IMMINGHAM EASTERN RO-RO TERMINAL

Applicant's Response to the ExA's
Fourth Written Questions

Document Reference: 10.2.81

January 2024

Figure 3. Maximum predicted zone of instantaneous peak PTS and TTS on grey seal during impact piling

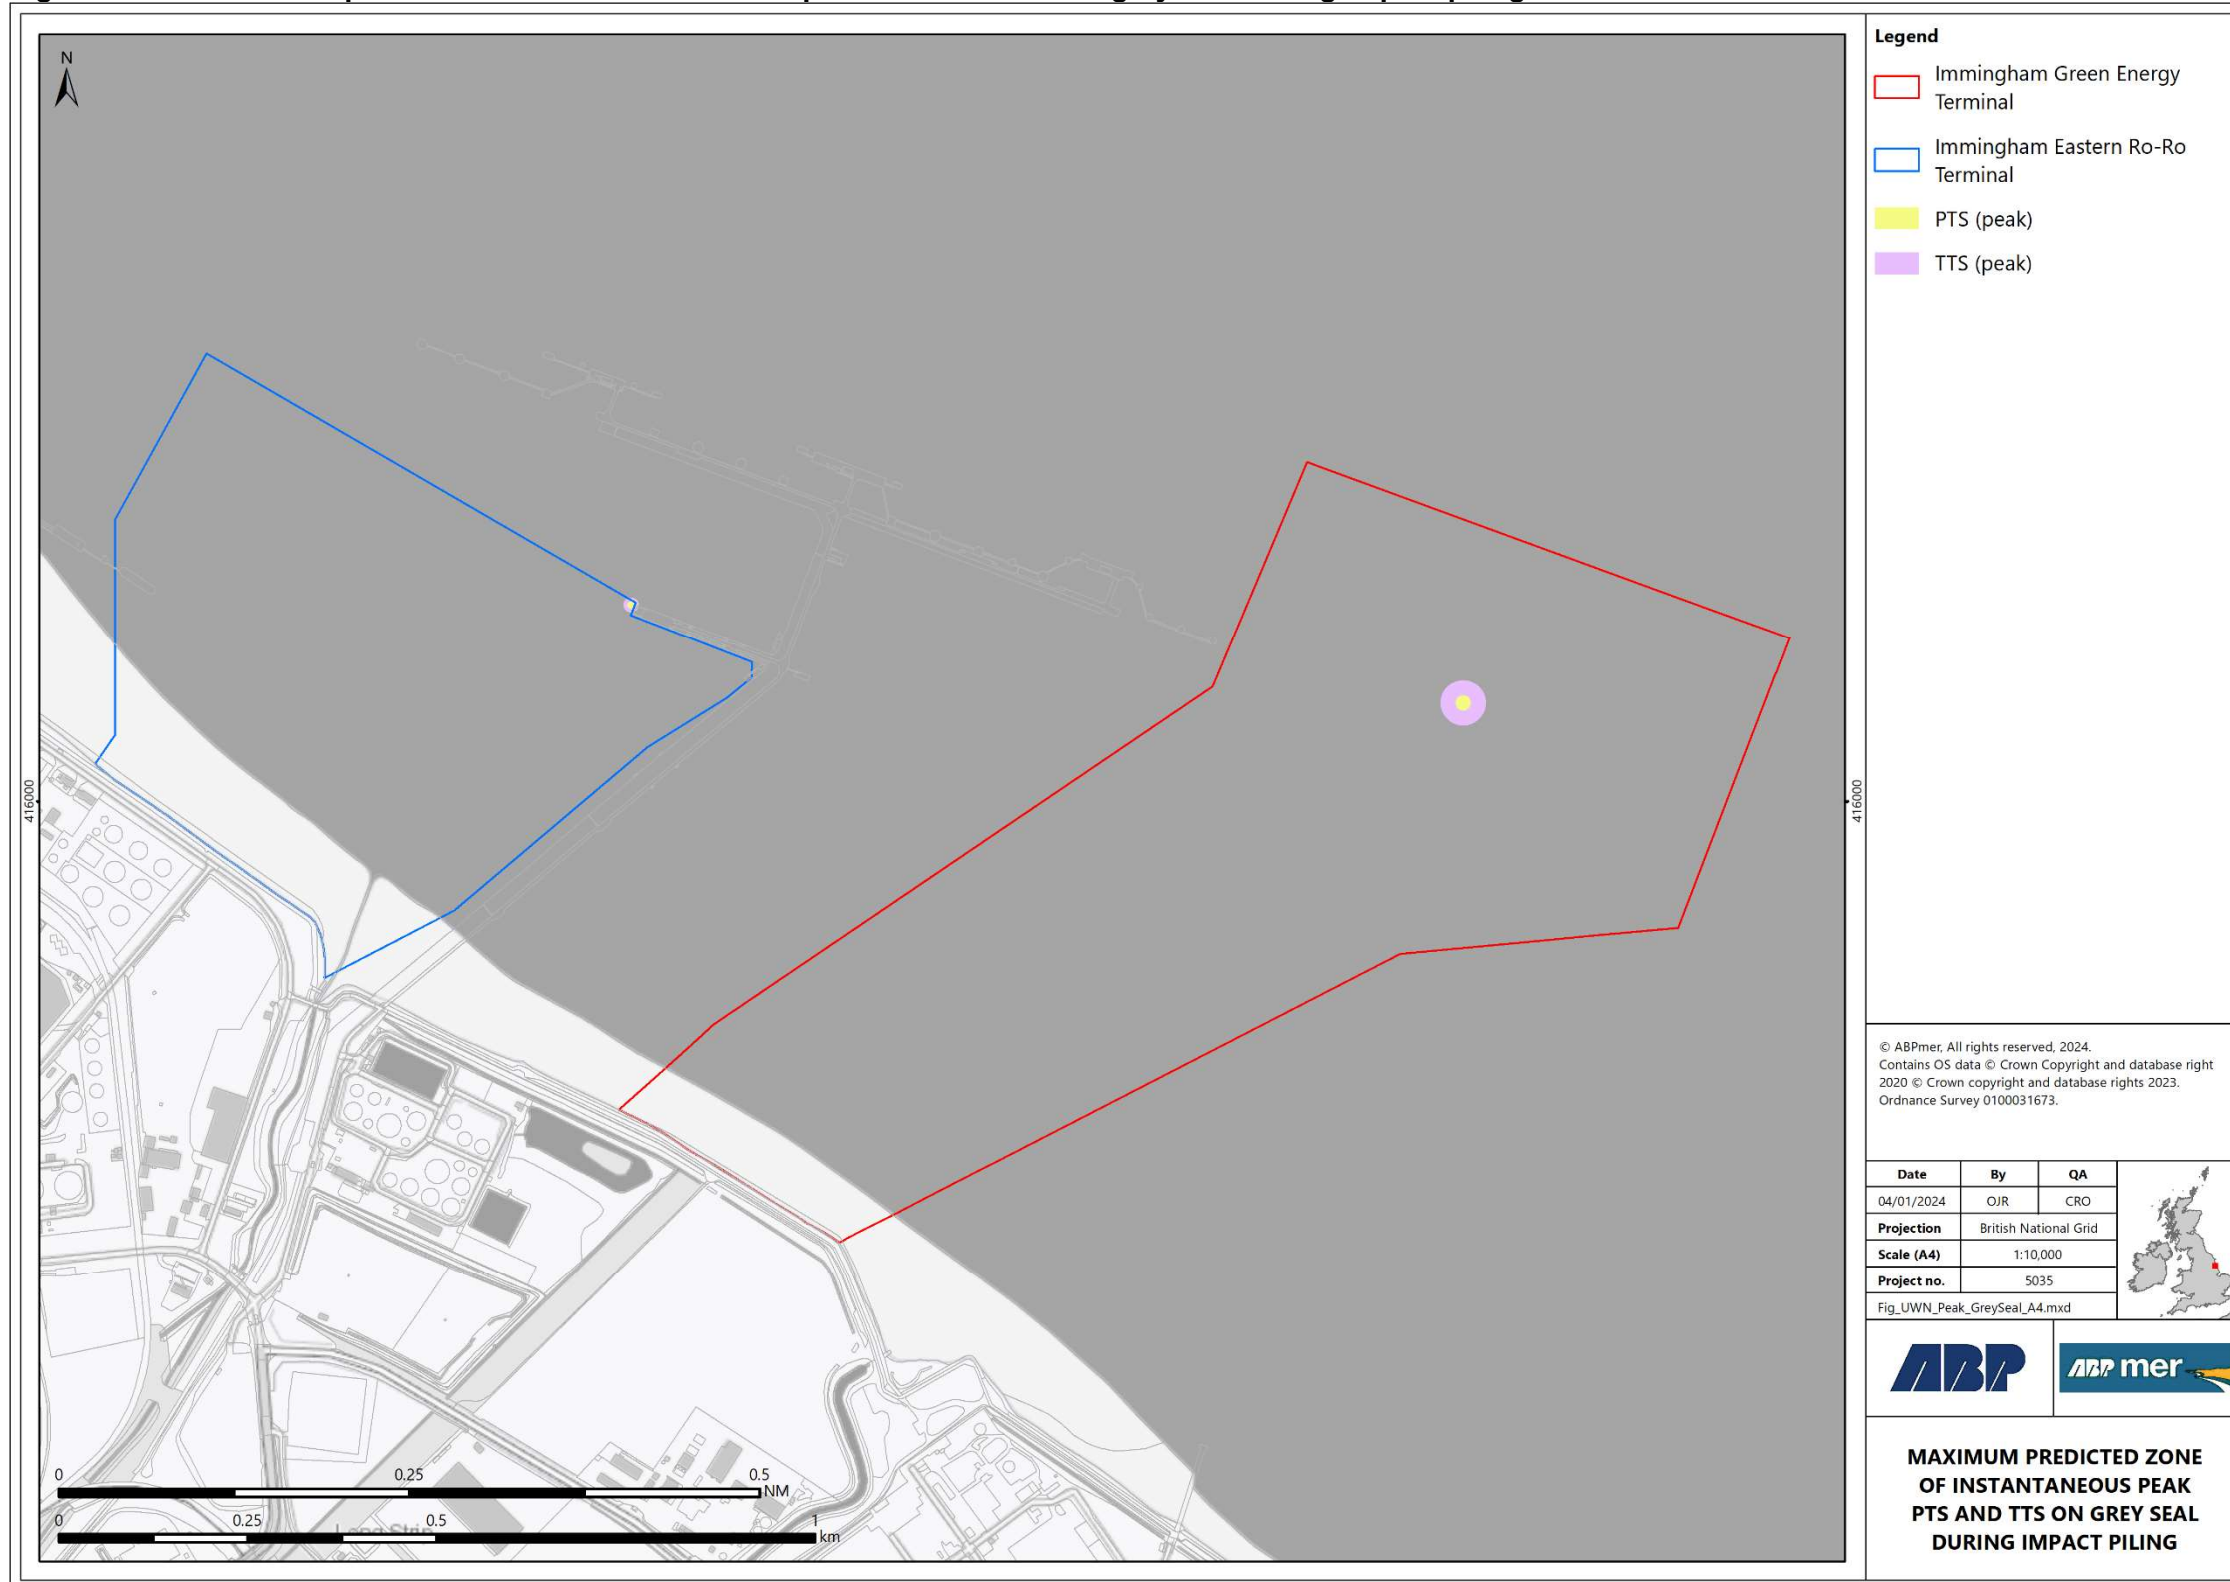
BNE.4.06	Applicant	<p>Quantifying the in-combination noise levels from the Proposed Development and the proposed Immingham Green Energy Terminal (IGET)</p> <p>Quantify the in-combination noise levels for the Proposed Development and the proposed IGET to justify your conclusions in Tables 37 and 39 of the HRA Report [REP7-014].</p>	<p>The marine construction activities for IERRT and Immingham Green Energy Terminal have the potential to overlap. Underwater noise from dredging for both projects is only expected to cause behavioural reactions in a relatively localised area in the vicinity of the dredger for both lamprey and grey seals.</p> <p>Underwater noise generated during piling required as part of the IERRT project along with the Immingham Green Energy Terminal works has the potential to result in cumulative effects on lamprey and grey seal features of the Humber Estuary SAC. The maximum potential spatial extent of instantaneous peak and cumulative Sound Exposure Level (SEL) effects on lamprey and grey seal if the construction activity for both projects were to overlap and occur at the same time are shown in Figure 1 to Figure 4. The predicted zones of effects are based on the highest underwater noise levels generated during the proposed works for each project (i.e. impact piling) and maximum worst case assumptions presented in the respective underwater noise assessments for IERRT and Immingham Green Energy Terminal.</p> <p>Figure 1 and Figure 2 illustrate that impact piling noise has the potential to cause injury effects in lamprey within close proximity to the piling activity and behavioural responses over a wider area of the Humber Estuary for both projects. Lamprey form part of the least sensitive noise hearing fish group according to the Popper <i>et al.</i> (2014) guidelines and the predicted zone of behavioural effects are based on the sound levels to which schools of sprat, which are in the highest sensitive noise hearing fish group, responded on 50% of observations (Hawkins <i>et al.</i>, 2014). The predicted behavioural zone shown in Figure 1 is therefore considered overly precautionary and conservative and is likely to be a more localised area for lamprey.</p> <p>Instantaneous peak Permanent Threshold Shift (PTS) and Temporary Threshold Shift (TTS) effects in grey seal are predicted to occur within close proximity to the impact piling activity and cumulative SEL PTS and TTS effects are predicted over a wider area (Figure 3 and Figure 4). Assuming seals evade the injury effects zone, they are not considered to be at risk of any instantaneous or cumulative injury effects during impact piling. Strong behavioural responses may occur over a wider</p>

<p>area although the existing constraints of the estuary are such that elevated underwater noise levels generated during piling for IERRT and Immingham Green Energy Terminal are physically constrained to within the outer section of the Humber Estuary and are unable to directly reach the grey seal breeding site at Donna Nook. The Spurn on the Outer Humber Estuary and promontory of Grimsby Docks means that much of the underwater noise will be limited by these hard constraints and will not propagate to the outer part of the estuary and beyond. In addition, the upstream bend in the estuary at Salt End will mean that elevated underwater noise levels will not be able to propagate beyond this point. In other words, potential behavioural responses and/or displacement effects are primarily limited to the section of the estuary between around Salt End (upstream) and Grimsby to Spurn Bight (downstream).</p> <p>The maximum impact piling scenario for both projects should the piling works overlap is for up to 7 tubular piles to be installed each day (4 piles for IERRT and 3 piles for Immingham Green Energy Terminal) using up to 6 piling rigs driving at any one time (4 piling rigs for IERRT and 2 piling rigs for Immingham Green Energy Terminal). If none of the pile driving activity for both projects were to occur at the exact same time and temporally overlap over a 24-hour period, the maximum impact pile driving scenario would involve approximately 80 minutes of vibro piling per day (20 minutes for IERRT and 60 minutes for Immingham Green Energy Terminal) and 450 minutes of impact piling per day (180 minutes for IERRT and 270 minutes for Immingham Green Energy Terminal).</p> <p>Any disturbance and barrier to lamprey and grey seal movements caused by the noise during piling for IERRT and Immingham Green Energy Terminal would be temporary with periods during a 24-hour period when no piling will be undertaken. The proportion of impact piling is estimated to be at worst around 31 % over a 24-hour period (based on 450 minutes of impact piling per day). In other words, any lamprey and grey seals that remain within the predicted behavioural effects zone at the time of impact piling will be exposed a maximum of up to 31 % over the period of a day. The proportion of vibro piling is estimated to be at worst around 6 % over a 24-hour period (based on 80 minutes of vibro piling per day). In other words, any lamprey and grey seals that remain within the predicted behavioural effects zone at the time of piling will be exposed a total maximum of up to 37 % over the period of a day. In reality, less than 7 piles are likely to be driven per day and also there is likely to be some temporal overlap in the pile driving activity, therefore, the assumptions on maximum pile driving periods and daily exposures are considered to represent a worst case. Piling will also not take place continuously as there will be periods of downtime, pile positioning and set up.</p> <p>The same mitigation measures are proposed for both IERRT and Immingham Green Energy Terminal Projects to help minimise potential adverse effects (i.e., soft start procedures, timing restrictions to avoid sensitive periods for migratory fish and the use of marine mammal observers). In order to take account of any potential in-combination effects should the piling programmes for both projects overlap, it is proposed that the maximum duration of percussive piling permitted within any 4-week period must not exceed a total of 196 hours where any percussive pile drivers for either one or both projects are in operation. Where percussive piling is occurring simultaneously across the two projects these respective time periods will not be double counted as the temporal exposure to this effect is not increased. This</p>
